# Access Compliance Report

## Public Rights-of-Way

Intersection ID: 30383	Main Street: BELLSOUTH_DR	Cross Street: CENTRAL_AV	Location: SW
ADA ID: E921842A6788	Ramp Type: Perp	Initial Pass/Fail: Fail	Overall Compliance: No
Severity Score: 8.75			
Codes/Mitigation Info/Possible Solution		Field Measurements/Component Compliance

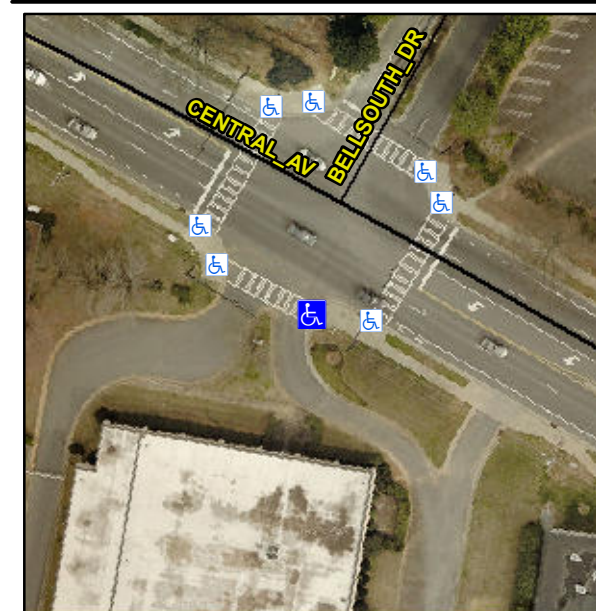
**Not Found, R304.5.1**

Compliance	Description	Data	Compliance	Description	Data
N/A	Ramp Length (in)	28.5	Yes	Ramp Slope (%)	5.3
No	Ramp Width (in)	47.0	Yes	Ramp XSlope (%)	1.1
N/A	Flare Type LT	N/A	N/A	Flare Type RT	N/A
N/A	Flare Slope LT (%)	N/A	N/A	Flare Slope RT (%)	N/A
N/A	Flare Traversable LT?	N/A	N/A	Flare Traversable RT?	N/A
N/A	Landing Length (in)	N/A	N/A	DWS Provided?	N/A
N/A	Landing Width (in)	N/A	N/A	DWS Contrast?	N/A
N/A	Landing Slope (%)	N/A	N/A	DWS Length (in)	N/A
N/A	Landing X Slope (%)	N/A	N/A	DWS Full Width?	N/A
N/A	Landing Curb? (Y/N)	N/A	N/A	DWS Offset (in)	N/A
N/A	Shared Landing?	N/A			
N/A	Gutter Ponding?	N/A	N/A	Gutter Slope (%)	N/A
N/A	Gutter Lip Ht (in)	N/A	N/A	Gutter X Slope (%)	N/A
N/A	Painted X Walk1?	Yes	N/A	Painted X Walk2?	N/A
	X Walk 1 Direction	To NW		X Walk 2 Direction	N/A
N/A	X Walk 1 Width (in)	116.0	N/A	X Walk 2 Width (in)	N/A
	X Walk 1 Slope (%)	0.1		X Walk 2 Slope (%)	N/A
	X Walk 1 X Slope (%)	0.5		X Walk 2 X Slope (%)	N/A

**Remove & Replace Entire Ramp.**
